# Staff Report of Investigation Addendum

In the Matter of the Application of Duke Energy
Ohio for a Certificate of Environmental
Compatibility and Public Need for the Construction
Of the C 338 Ohio River to Bethel Natural Gas
Pipeline Project Located in Clermont County, Ohio

Duke Energy C338 Ohio River to Bethel Natural Gas Pipeline

### Figure 6

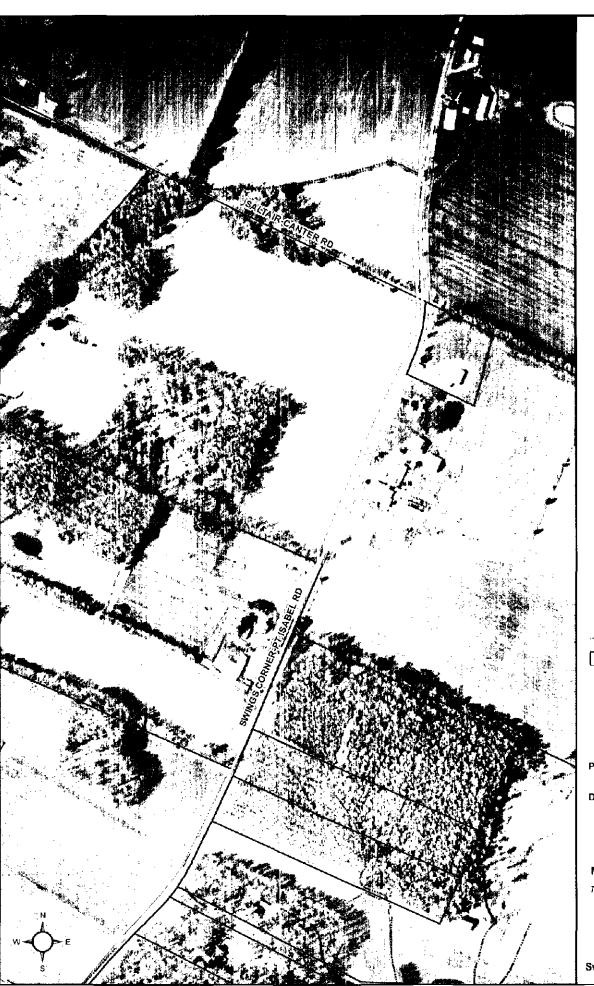
Since filing their original application, the Applicant has found it necessary to submit several Preferred Route alignment changes. These route clarifications were filed on: January 23, 2007, January 26, 2007, and February 27, 2007. (See attached Figures.) These clarifications were mostly prompted by recent communications about previously installed utilities. The Applicant must maintain essential engineering clearances to minimize potential conflicts with existing utilities. The Applicant also has had to adjust the Preferred Route to accommodate easement requirements and restrictions.

The Staff has inspected the Applicant's proposed changes to the Preferred Route. The Staff concludes that these clarifications are consistent with the overall requirement to minimize impacts. Therefore, Staff finds that these clarifications are beneficial. Staff recommends that the Board certificate these changes to the Preferred Route and that conditions included with this addendum become part of any certificate issued for the proposed facility.
